TO: District of Columbia Zoning Commission
FROM: Stephen Cochran, Development Review Specialist
JL for Jennifer Steingasser, Deputy Director, Development Review & Historic Preservation
DATE: September 3, 2020
SUBJECT: Report on Zoning Commission Case No. 21-09 – Application by US Union Square DC 899 LLC et al. for Downtown Design Review for 899-901 North Capitol Street, N.E.

ZC 21-09: 899, 901 and 999 North Capitol Street, NE

Figure 1. Phases 1 and 2 Site Plan. Areas in Yellow are New Construction.

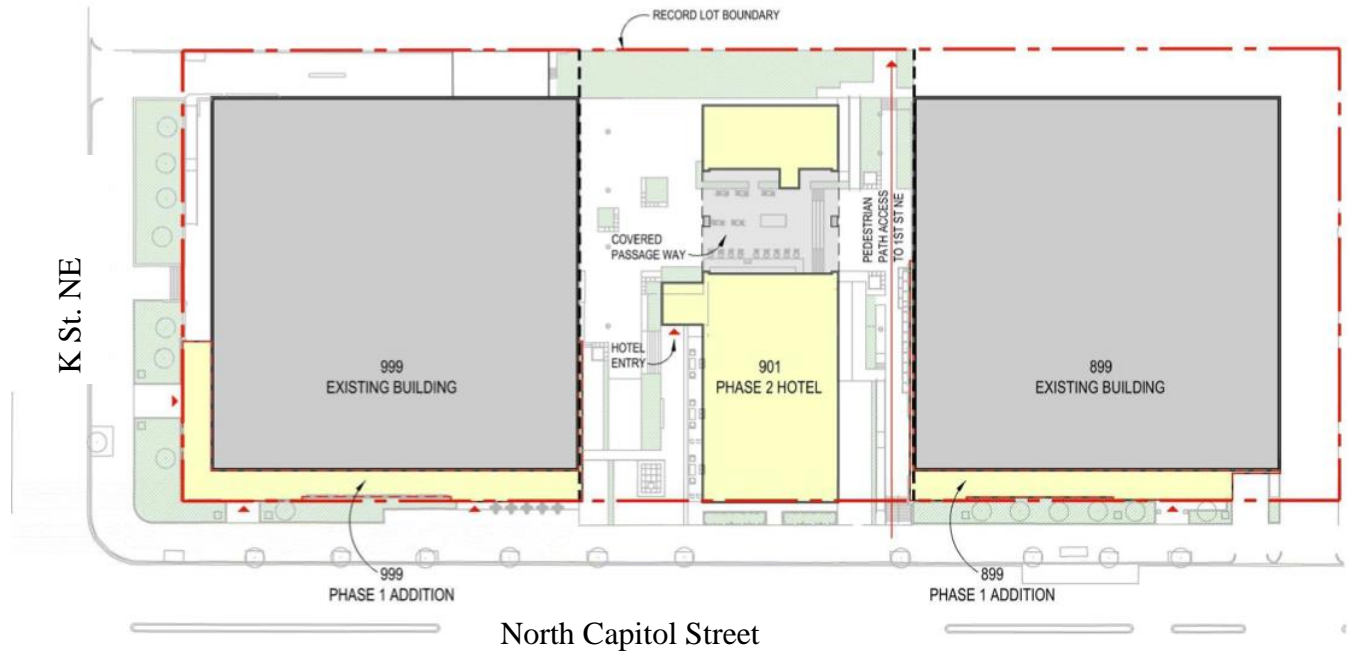
The existing buildings are set back approximately 15-feet from the North Capitol Street and K Street property lines. The lowest half of the first floor is sunk approximately four to seven feet below-grade, depending on location. Renovations would not change the exterior appearance of existing buildings 2nd through 9th floors or the penthouse. However, there would be 1 ½-story additions that would fill in the below-grade area behind the property line along North Capitol Street and a portion of K Street. The space in the north building would be primarily for offices, although the southwest corner of the first floor and first below-grade level would be used for retail space that would open to both North Capitol Street and the central plaza. The space in the south building would provide for a new entrance on North Capitol Street and for a double-height lobby. That addition would not contain retail space. The existing buildings are light in color and of modern design using light aggregate and glass, while the additions would be contemporary, employing grayish brick, glass, steel, and metal panels.

The second phase would be a new free-standing wood-framed seven-story, 85-foot high, 102-room hotel constructed atop the plaza between the two existing buildings. The western face would be flush with the North Capitol Street property line, which would place it approximately 15-feet closer to North Capitol Street than the 2nd to 9th stories of the existing buildings. Other than the entry pavilion on the north side, 64 feet of the plaza would remain on the north side of the building and 39 feet would remain on the south side. A 50' by 69' space at the ground level would be left open to the air and covered above that level, to connect both sides of the plaza. The southern portion of the plaza, which is in the former right of way of I Street, NE would remain open to enhance an existing pedestrian connection between North Capitol Street and 1st Street on the applicant's property and the property to the east.

The project would conform to this provision. The proposed additions and new building would not intrude on the North Capitol Street axis. The two existing light aggregate and glass modernist buildings are set-back approximately 15 feet from the North Capitol Street property line. Their Phase 1 1 ½ story brick-steel and glass additions would be at or within a few feet of the North Capitol property line. The proposed new Phase 2 dark-red brick hotel building would be constructed to that property line so would help to define the North Capitol Street axis, is relatively low compared to other buildings in the 800 and 900 blocks of North Capitol Street's east side and its color and materials would be balanced by the larger context by other buildings to the north, west and south. It should not detract from the view to the Capitol Dome.

All the new construction would be on or within four feet of the North Capitol Street property line.
